**COUNTY OF VENTURA
PUBLIC WORKS AGENCY**

MEMORANDUM

SUBJECT: Piru Area Plan Amendment Technical Memo - Circulation / Lane restriping

Figure 5.1 Mitigated Design Concept

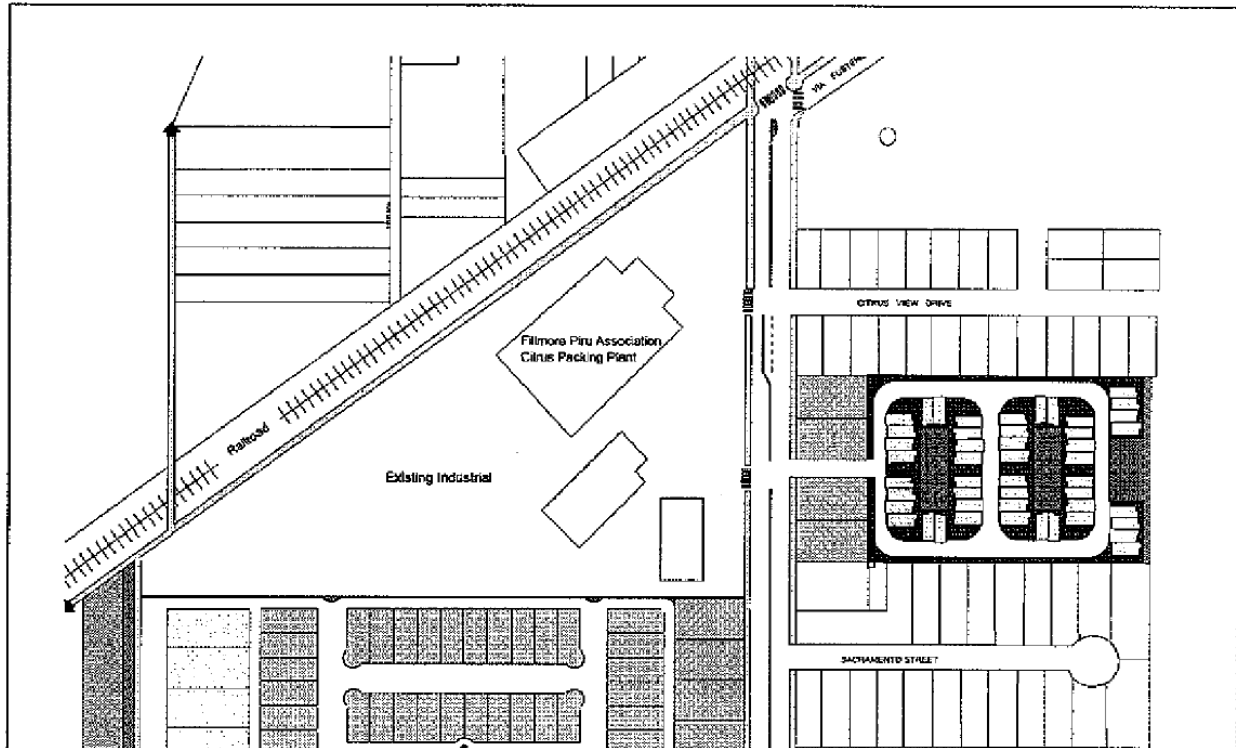
Proposed revisions to the Piru Area Plan, published as part of the Final EIR (Feb. 2006, pg. 71) includes the following revision to Transportation and Circulation Policy 4.1.2-3: At the Fillmore-Piru Citrus Association packing house, a left-turn lane shall be provided to facilitate truck access to the packing house. On-street parking at the packing plant should be eliminated and the multi-purpose pathway should be carefully designed with signage and pavement markings to minimize potential safety conflicts with packing house truck traffic. South of the intersection with Via Fustero, a landscaped median island shall be provided (Figure 14). Both of these features are shown in the figure above.

The installation also appears to be the result of a request from the Fire Protection District. (Final EIR Appendices, Feb. 2006, pg. 177)

Based on the findings of our turning movement study, and the truck turning templates demonstrated above, PWA can support the request to remove the concrete median, center turn median and dedicated left turn pocket along the packing plant through the necessary revisions to the Piru Area Plan and EIR.

Below are before and after images of the access to the packing plant driveway:

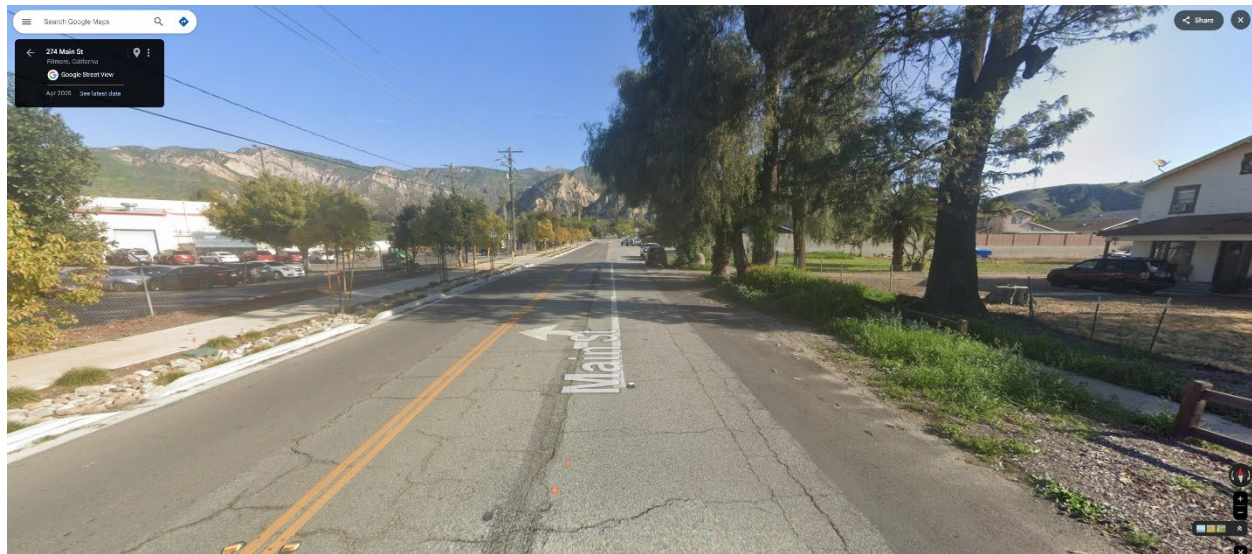
Below are two photos of a tractor trailer making a left turn from the through lane, not even using the installed left turn pocket.

Trucks were found to be performing this maneuver of making a left turn by straddling the left turn lane and thru lane, or entirely from the thru lane because the location of the left turn pocket with respect to the relocated driveway entrance has reduced the turning radius from the street into the driveway, making a more difficult turn for the drivers. This maneuver also creates a safety issue: Due to the tight turning radius, the back end of trucks making a left from the turn pocket sometimes swing into the northbound through lane creating a potential conflict for vehicles trying to pass turning trucks.

- a) Turning radius for the approximate location prior to the installation of the turn lane and relocated western curb.

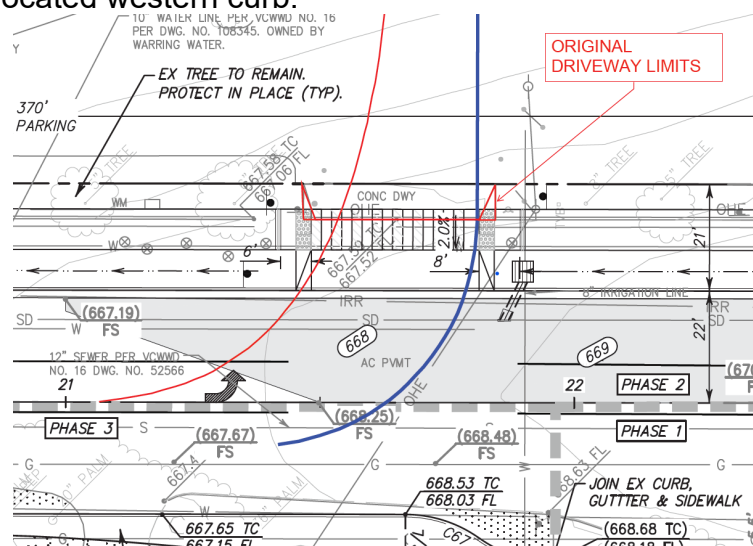
The images below demonstrate the turning radius of a WB-67 tractor trailer entering the packing plant from Main Street. A common truck that enters the plant would have double shorter trailers that can more easily maneuver a tighter turning radius; however, a WB-67 tractor trailer turning template is used to demonstrate a typical full-sized tractor with single trailer that occasionally enters the packing plant, as witnessed in the two photos in the previous paragraph.

Figure P-21 Intersection Enhancements at Main Street and Via Fustero

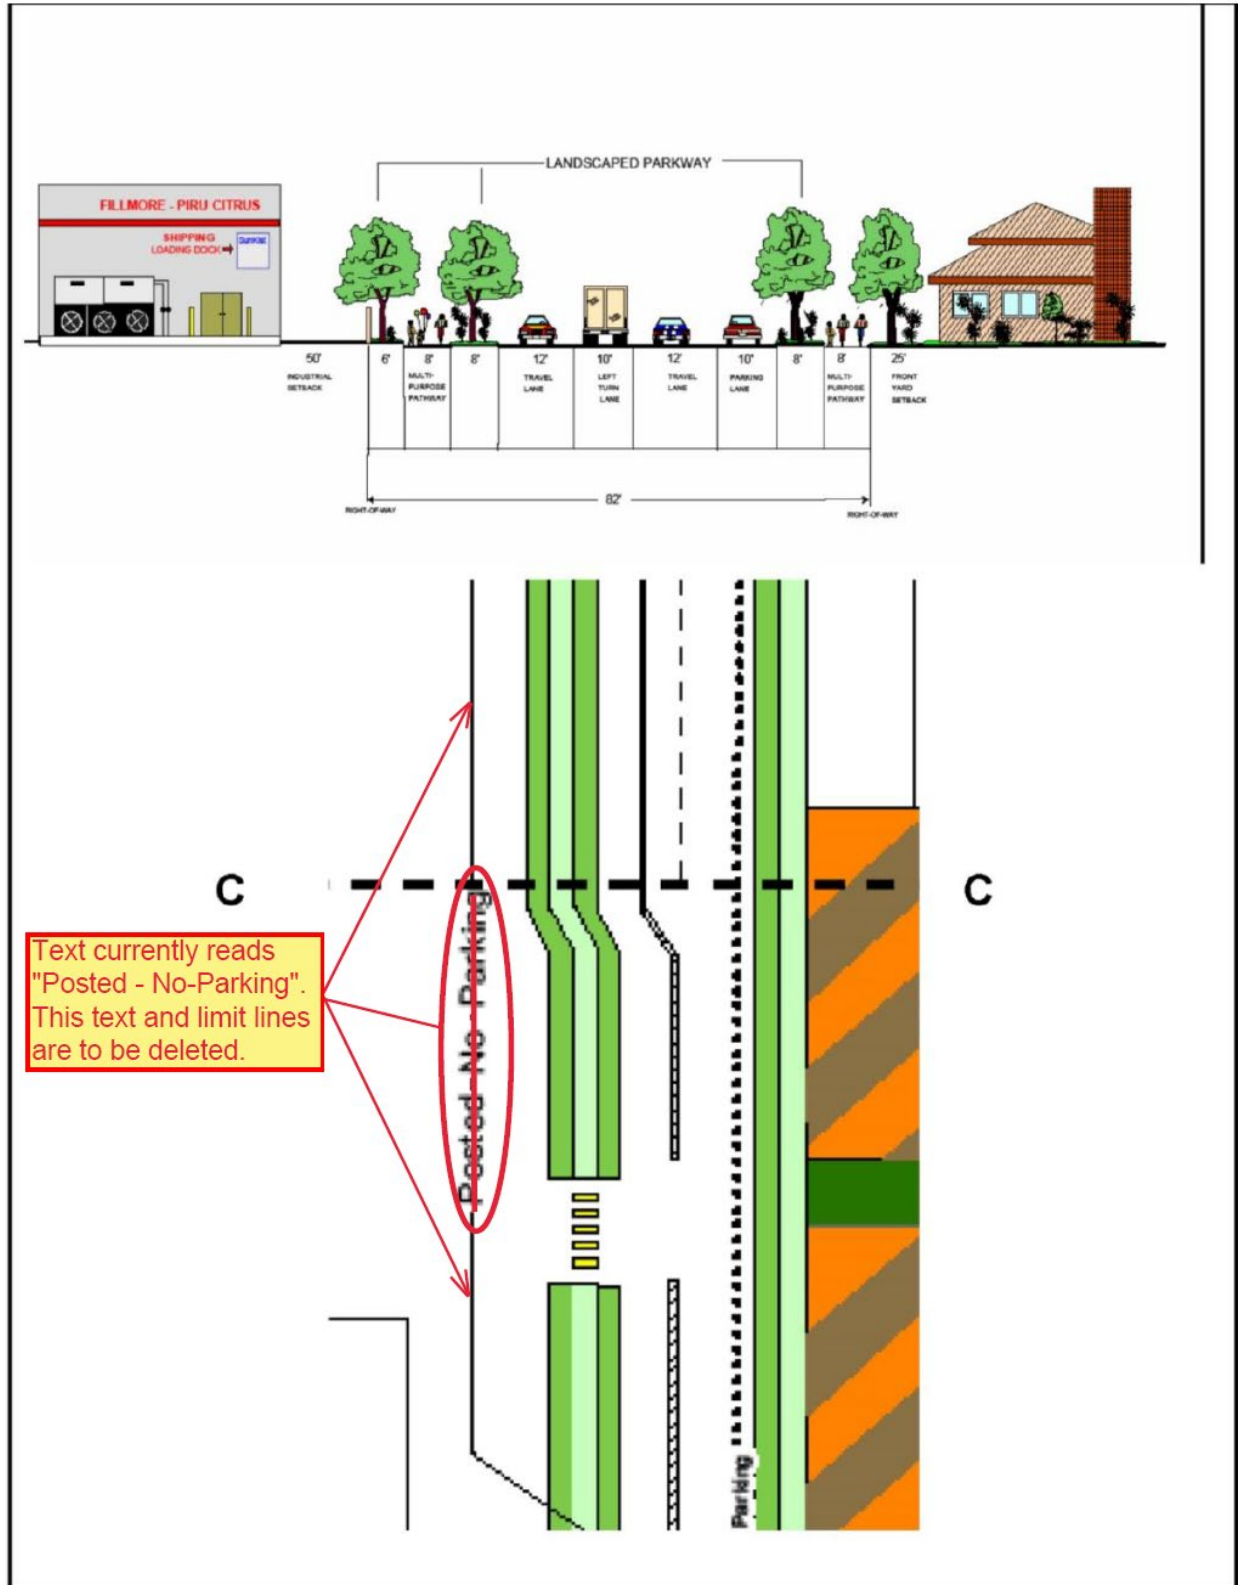
Below are revised Table P-6 (Description of Proposed Circulation Improvements), Figure P-17 (Main Street Concept Plan), Figure P-20 (Enhanced Main Street – Cross Section “C”) and Figure P-21 (Intersection Enhancements at Main Street and Via Fustero) demonstrating the conditions should removal of the concrete median, left turn lane, and striped “center turn median” be approved.
